**WHEELING PLAN COMMISSION
THURSDAY, SEPTEMBER 14, 2017 6:30 P.M.**

**AGENDA FOR A REGULAR MEETING OF THE PLAN COMMISSION
to be held in the Board Room of the Village Hall
2 Community Boulevard, Wheeling, Illinois**

REQUEST FOR PLAN COMMISSION ACTION
STAFF PROJECT REVIEW

LANDSCAPE PLAN

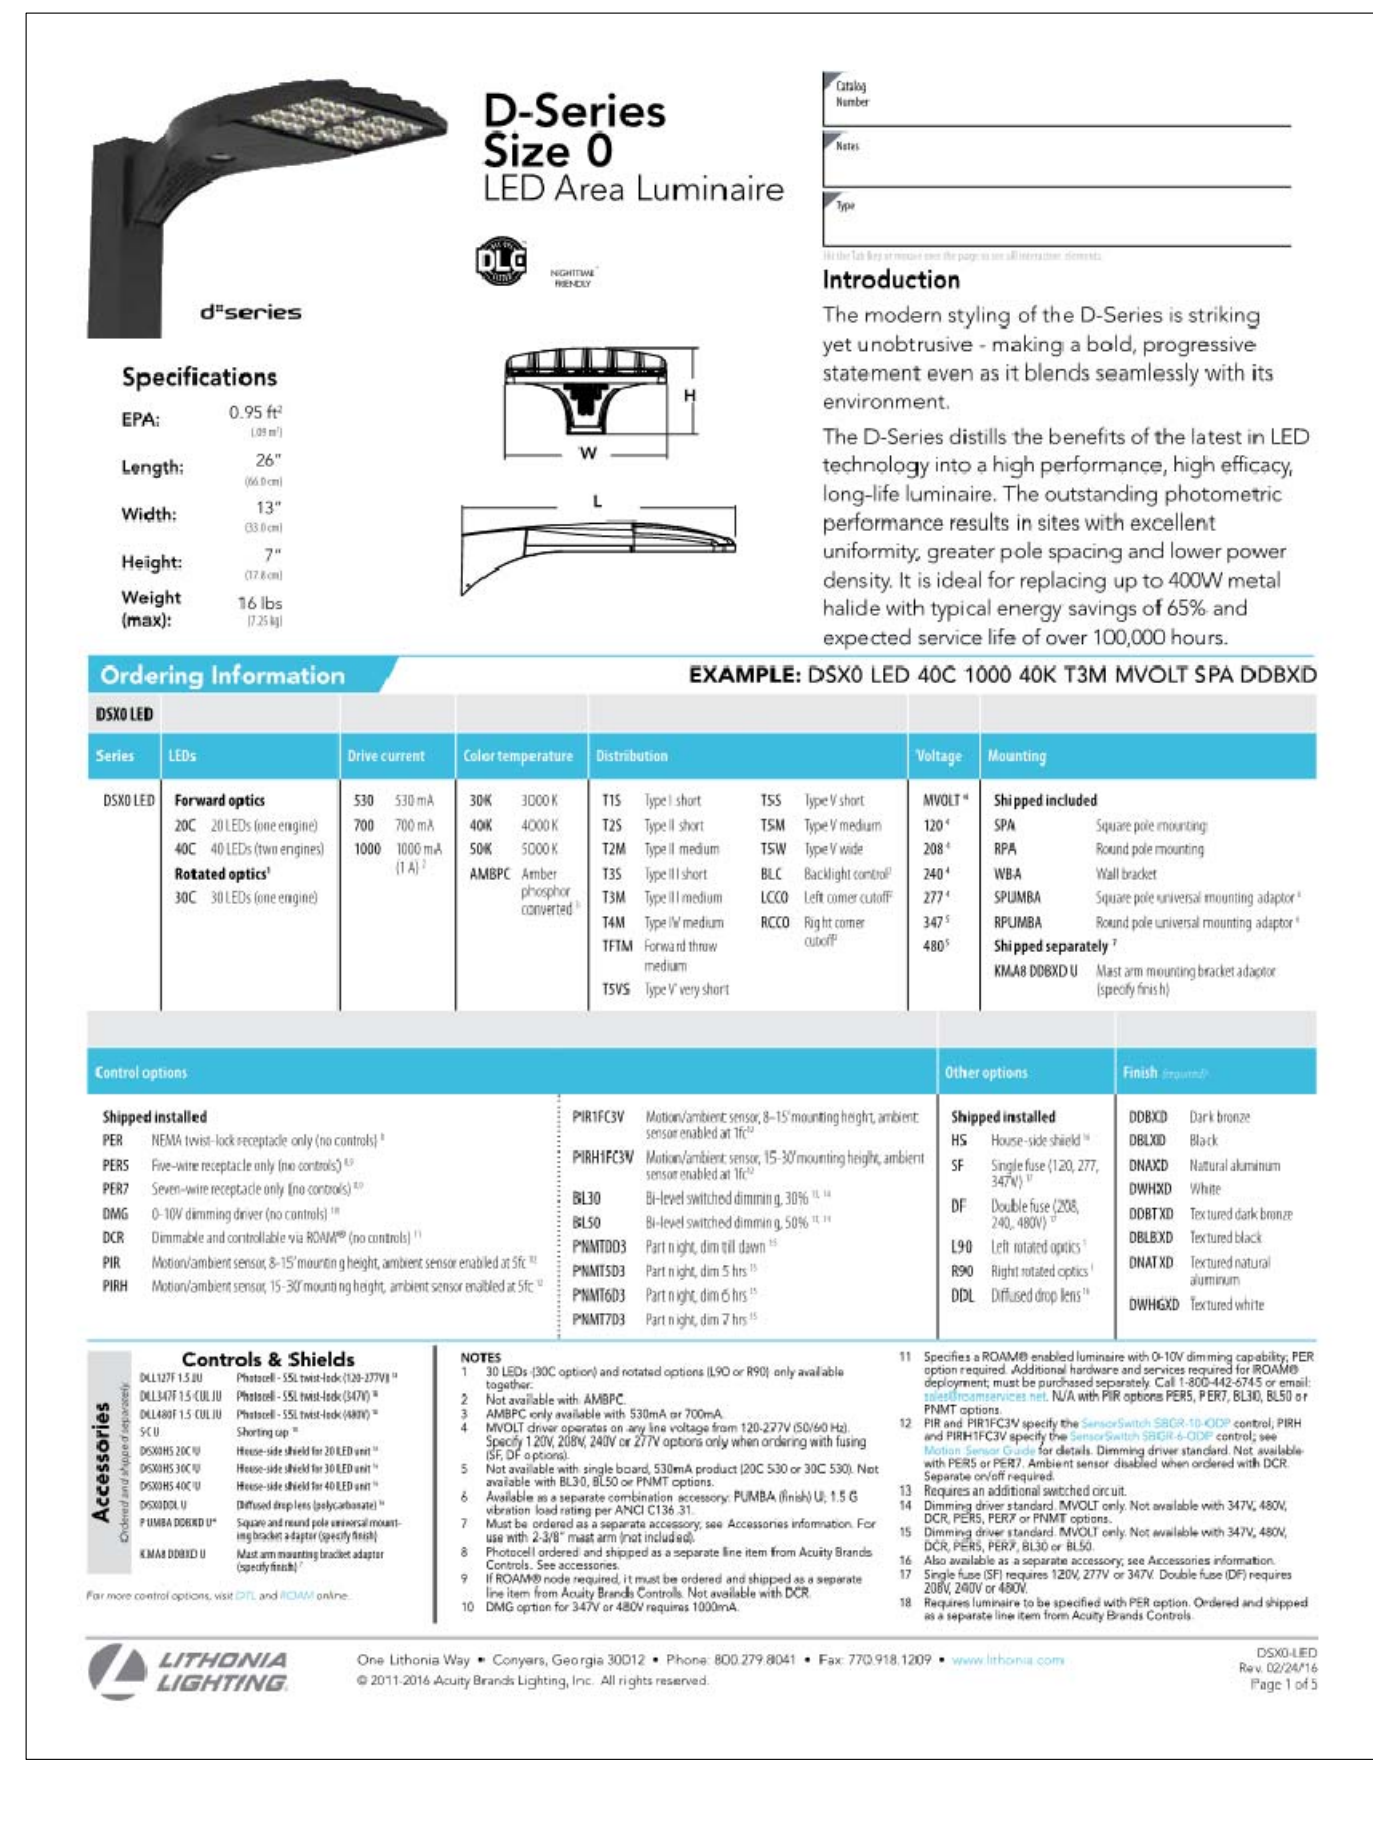
Landscaping Plan: The landscaping plan calls for a mix of shade and evergreen trees, ornamentals, evergreen shrubs, deciduous shrubs, decorative grasses and perennials. A detailed and illustrated plant portfolio has also been provided.

Landscape Irrigation: No reference to irrigation is noted in the plans. Staff has added a condition of approval that irrigation is required per code.
